MUNICIPAL CORPORATION.
KARACHI.

Re. Plot No. *52/1* Sheet No. *Jm 3*, *Jamshed* Quarter

With reference to your application dated 1st July 1939,
with a plan for the proposed buildings/additions and alterations on plot
No. 52/1 Survey Sheet No. J.M.3, Jamshed Quarter,
I have to request you to comply with the following requirements —

— AMENDED PLAN —
SHOWING PROPOSED FIRST FLOOR ON PLOT NO. 58 1/4 (505) J.M-3,
JAMSHED QUARTER.

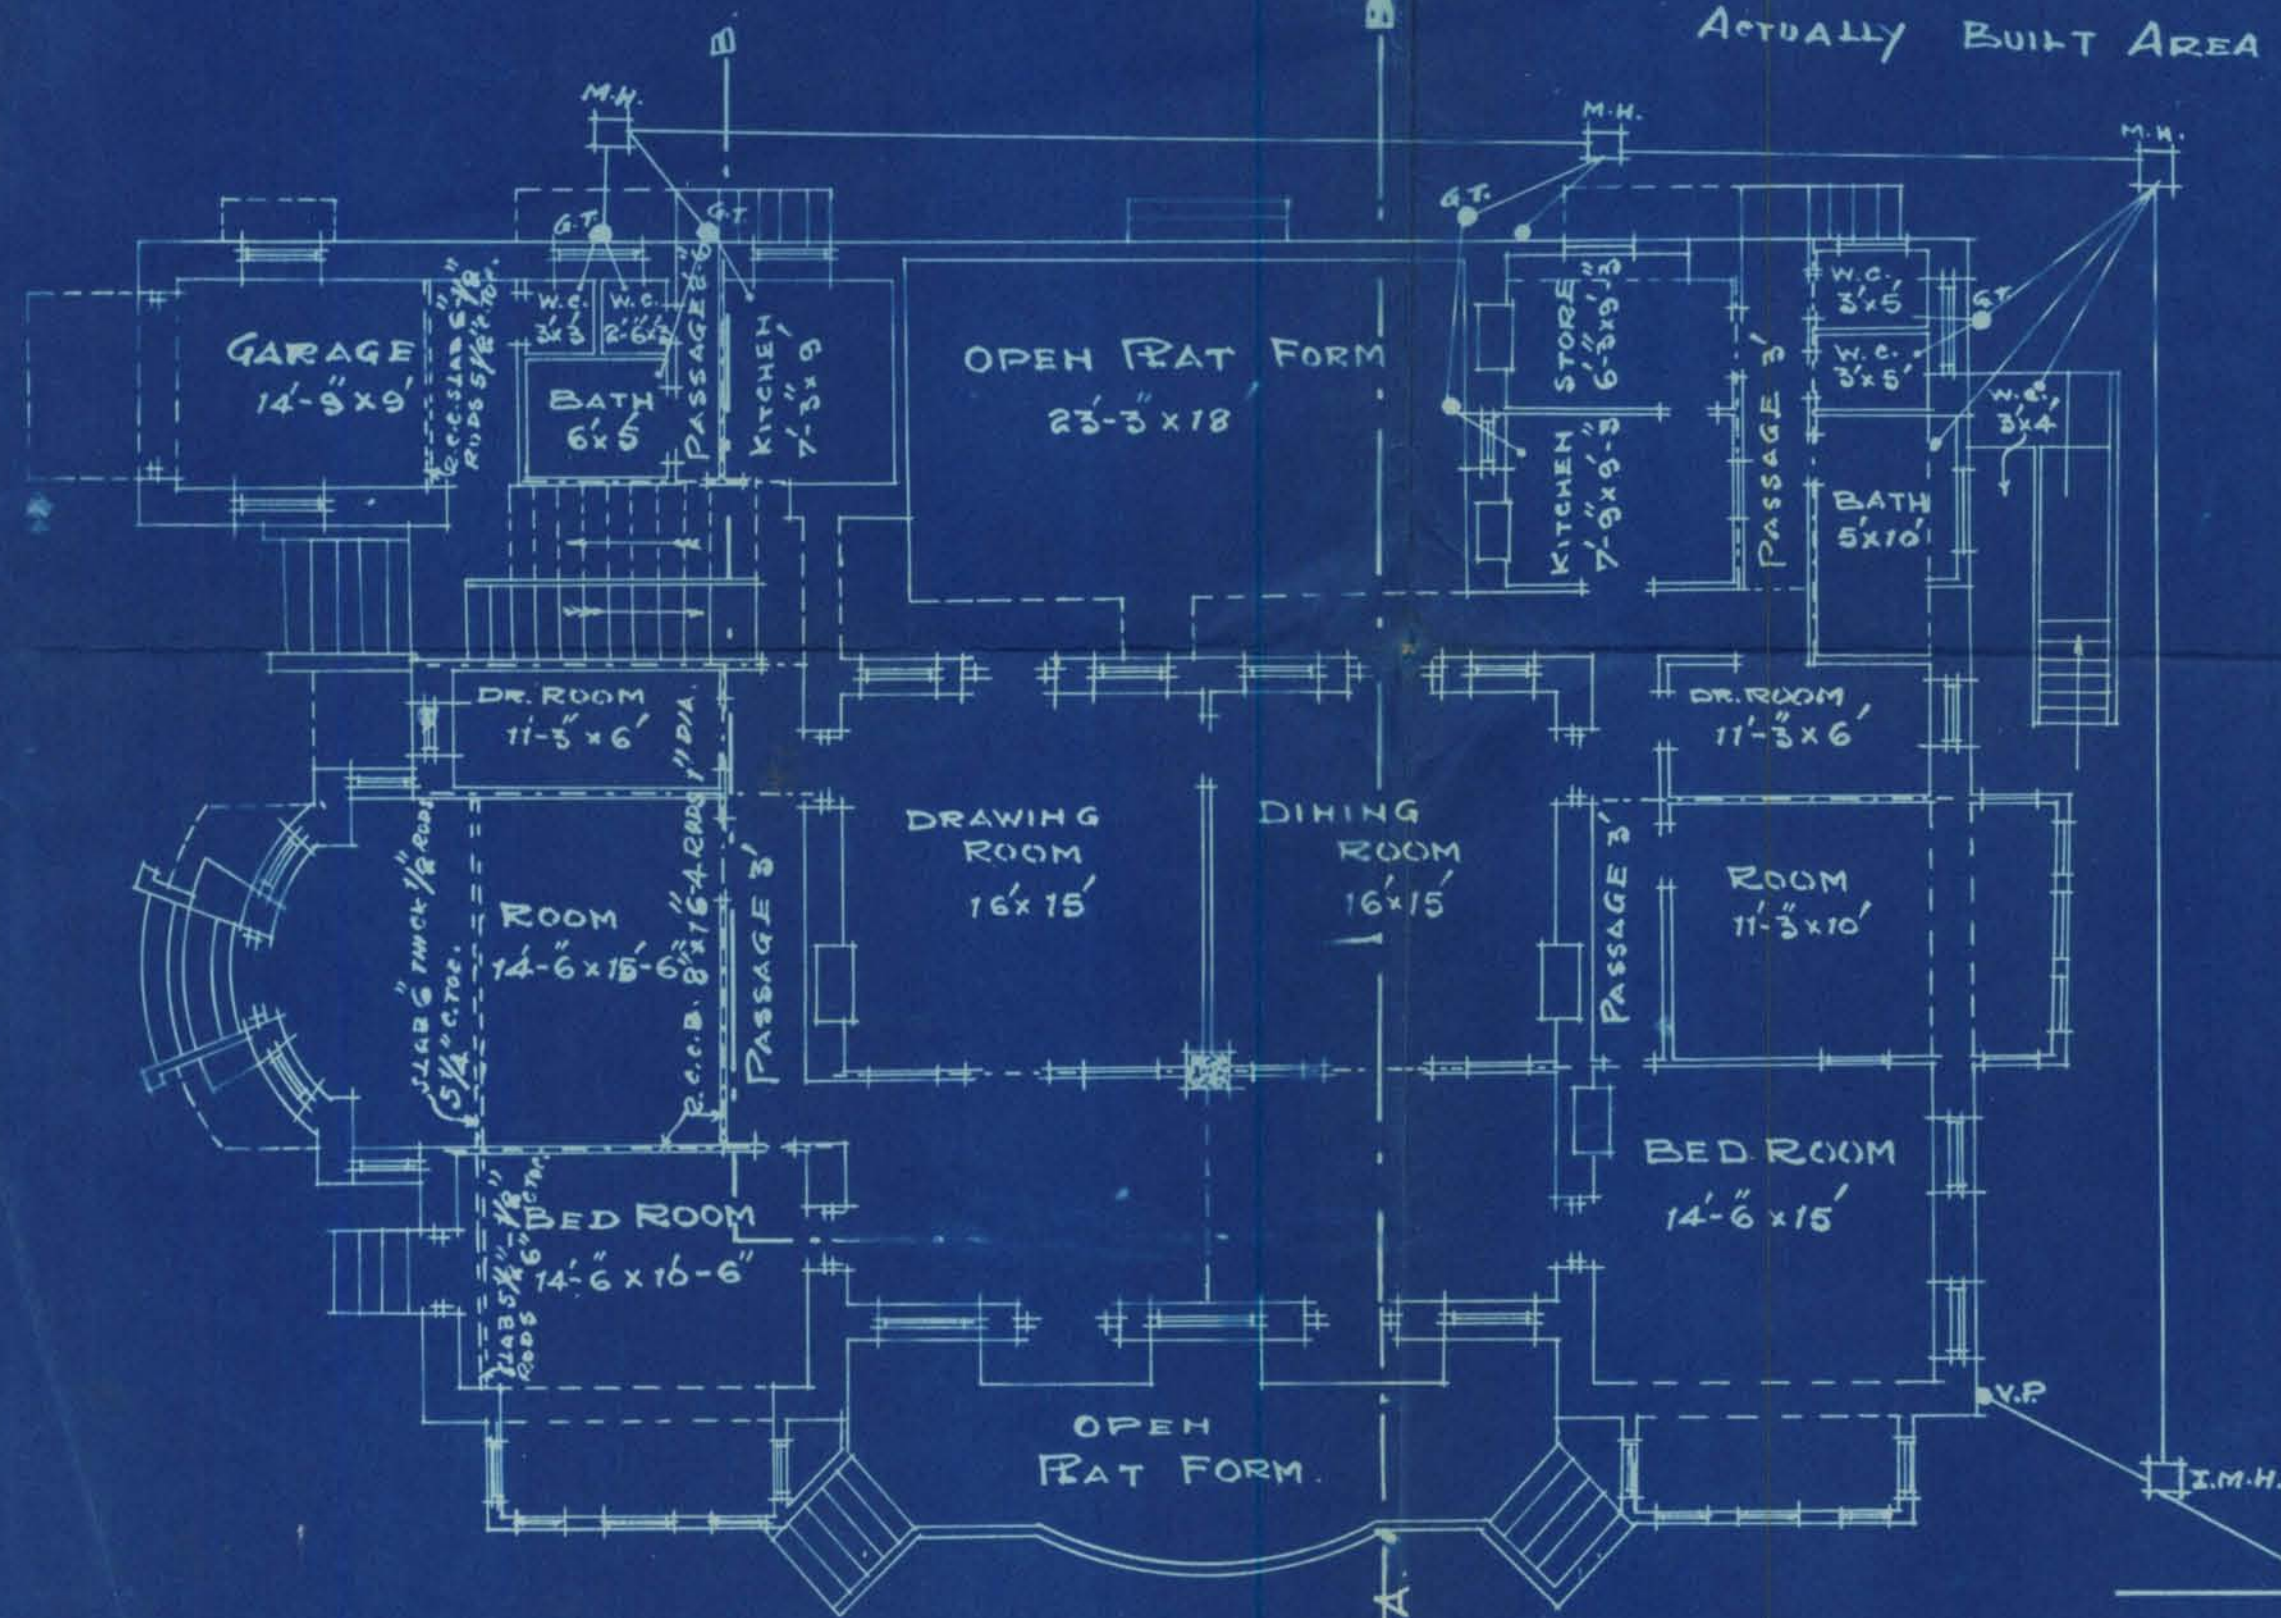
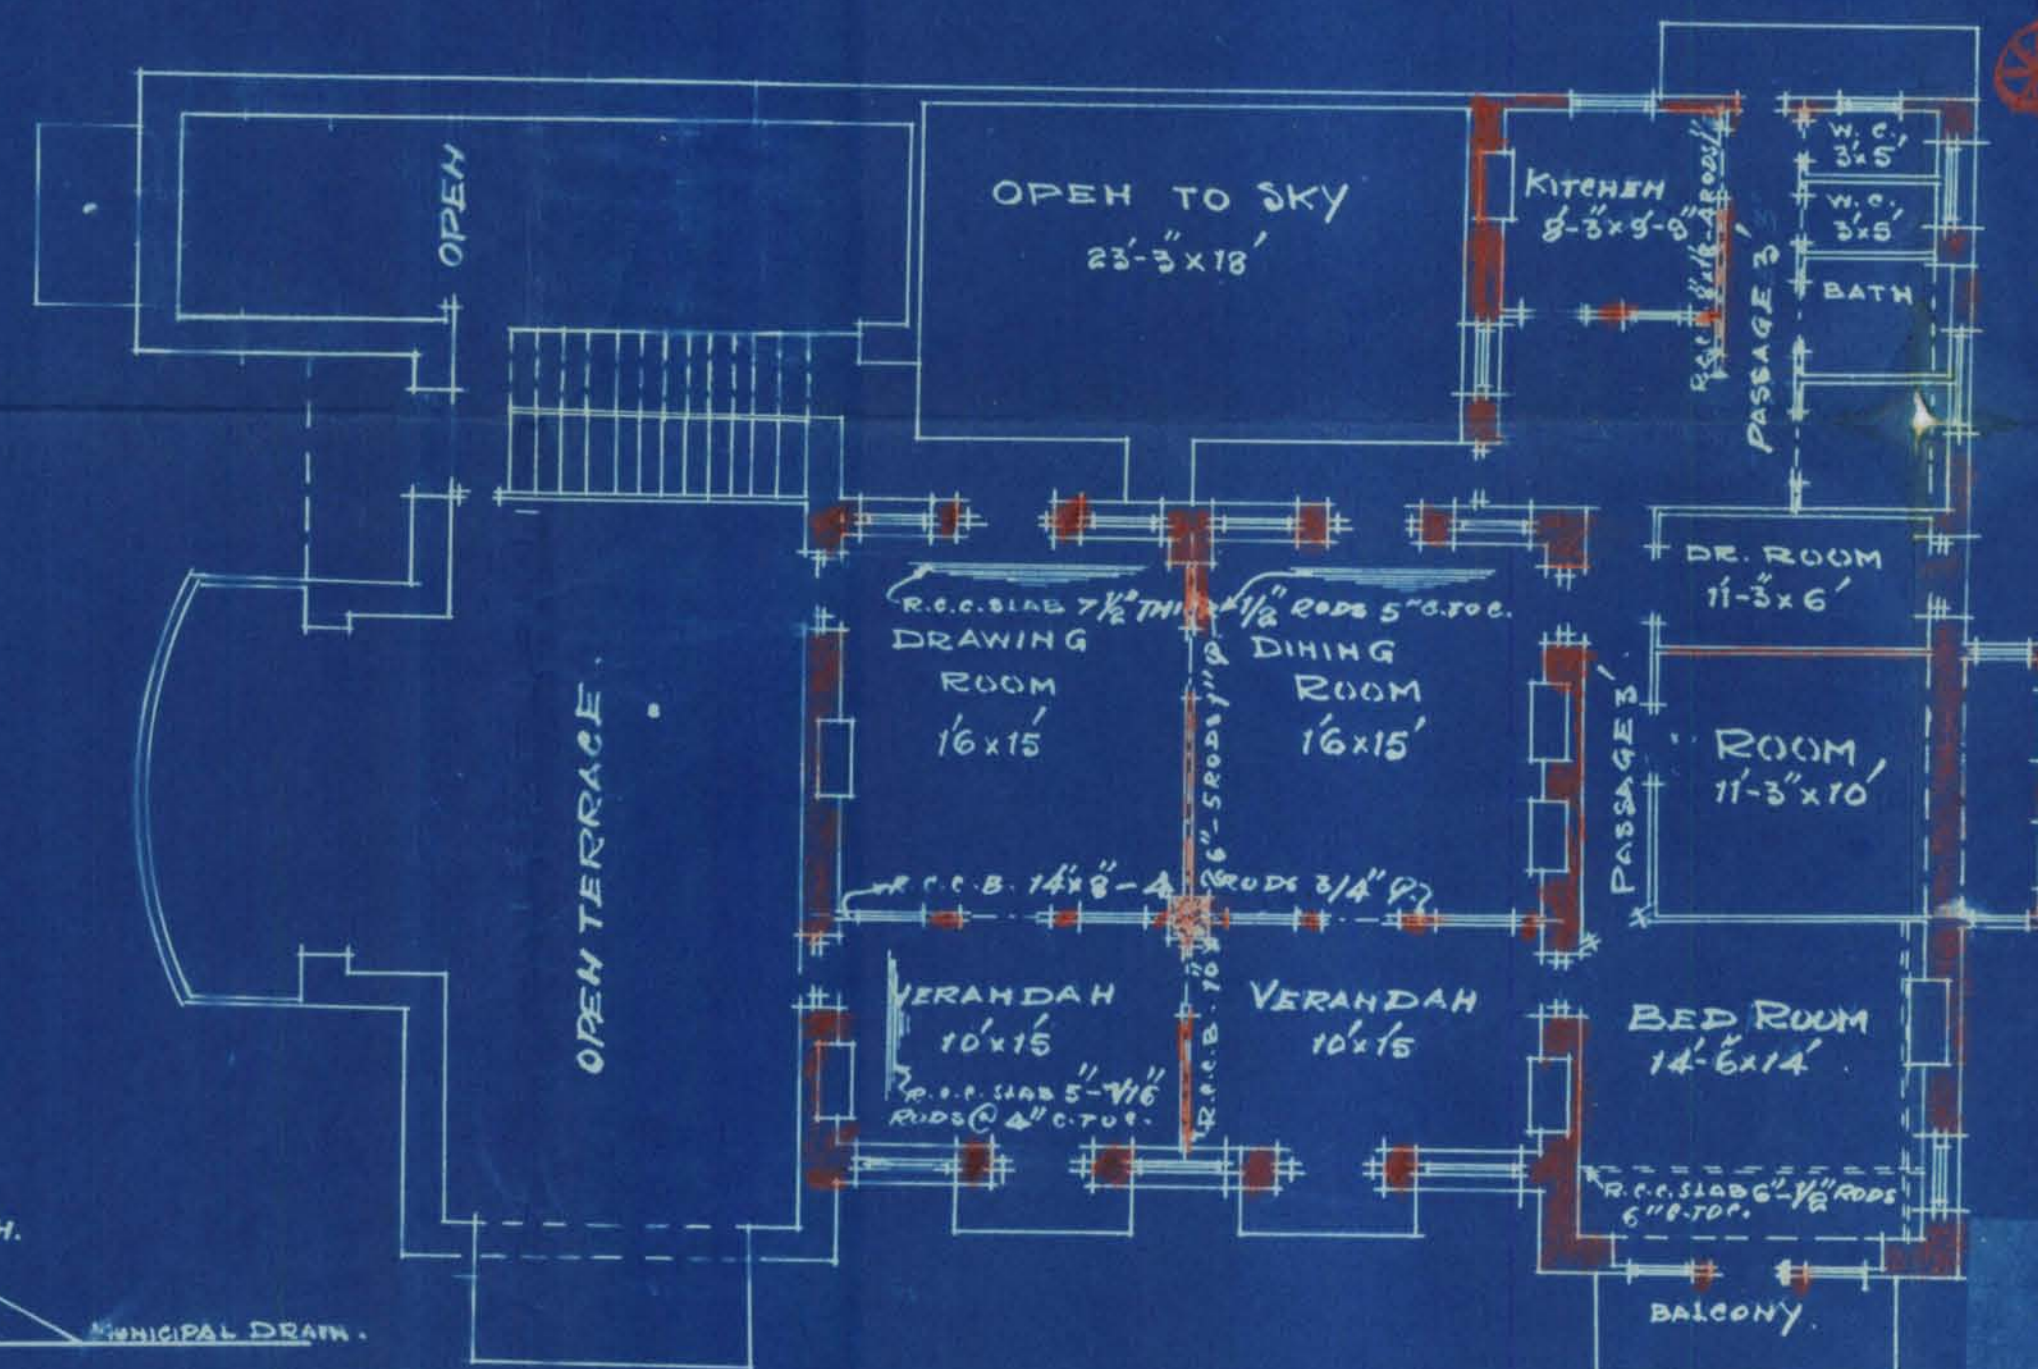
- (1) Complete site measurements must be shown.
- (2) Cardinal direction must be corrected.

- (3) Distances from the side bay-window and the spiral stairs
from the adjoining plots must be given, in the plan.
- (4) Actually built up area is shown as more than allowable.
This cannot be allowed.

1. Distances from the ^{side} bay window and the spiral stairs from the adjoining plots must be given in the plan.

2. Actually built up area is shown as more than allowable. This cannot be allowed.

- (1) Complied with
- (2) Complied with
- (3) Complied with
- (4) This excess area has been already condoned by the chief officer at the ~~final~~ time of approving the final plans for the ground floor. The same areas were shown in the original approved plans. The plans may kindly be approved at an early date & oblige.

Sub. to the L.T.S. From the above
file put up against for your per-
usal it will be seen that in
the gr. floor bldg, an excess of
44 sq. yds was found and the same
was condoned by the L.T.S. The present
Plan brings only for 1st floor no
additional area is covered up. The
L.T.S. has no objection and no
other objection remains

— SITE PLAN —
SCALE = 3/8" = 1' INCH.

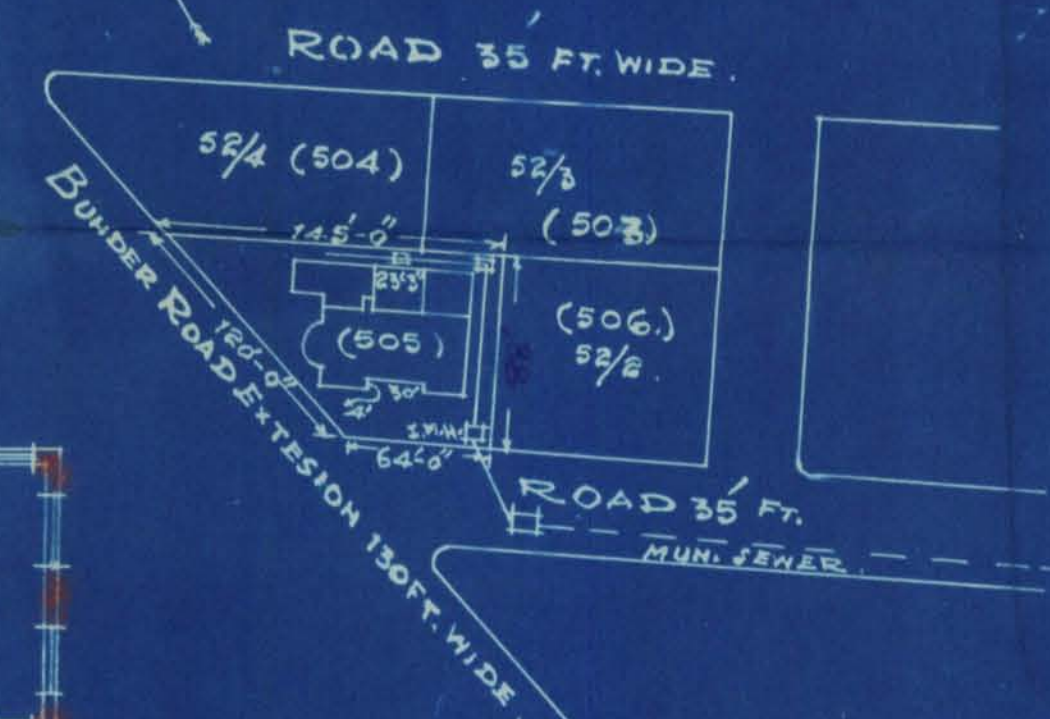
one of the site measurement not shown.

*No objection to
Site plan as
connected.*
